Subject: Arkansas Nuclear One - Unit 2
Docket No. 50-368
License No. NPF-6
Technical Specifications Change Request
Containment Isolation Valves

PROPOSED TECHNICAL SPECIFICATION

ARKANSAS NUCLEAR ONE, UNIT TWO

Figure 1
SIMPLIFIED SCHEMATIC
ANO-2 CONTAINMENT PURGE
SUPPLY AND EXHAUST

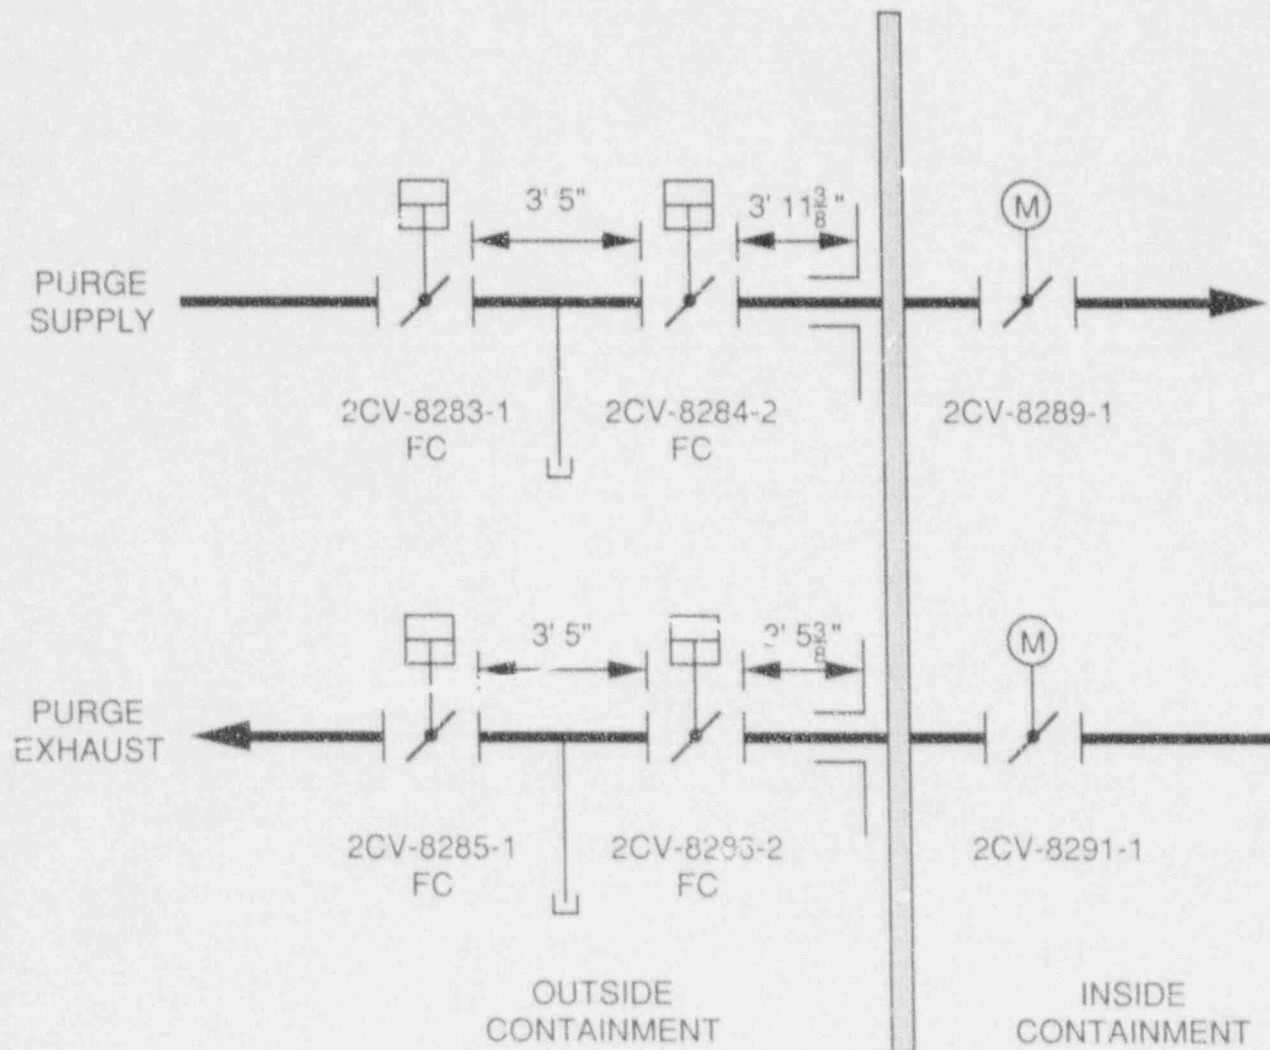
The proposed Technical Specification change removes the inboard containment purge isolation valves (2CV-8289-1 and 2CV-8291-1) from the listing of containment isolation valves in Technical Specification Table 3.6-1. The containment purge system is not credited for performing any safety-related function and is not required to operate during a design basis accident to maintain containment integrity. Containment integrity will be maintained by utilizing the redundant outboard isolation valves to provide a double barrier to the release of radioactivity following a design basis event. A vent line between the outboard isolation valves of the purge exhaust and supply lines was originally provided to route any potential leakage past the first outboard isolation valve to the Penetration Rooms Ventilation System. This line is now sealed closed with a welded pipe cap to maintain a double containment isolation barrier.

The only potential concern resulting from the use of the outboard valves to provide containment isolation is the possibility of tornado missile damage. The outboard isolation valves are located in close proximity to each other (distances between outboard valves are shown in Figure 1). This physical arrangement minimizes the piping between the isolation valves which could be subjected to potential tornado missile damage. Additionally, the purge supply and exhaust piping penetrate the containment building at an elevation approximately half the height of the building and are significantly shielded from horizontal tornado missiles by the containment and auxiliary buildings.
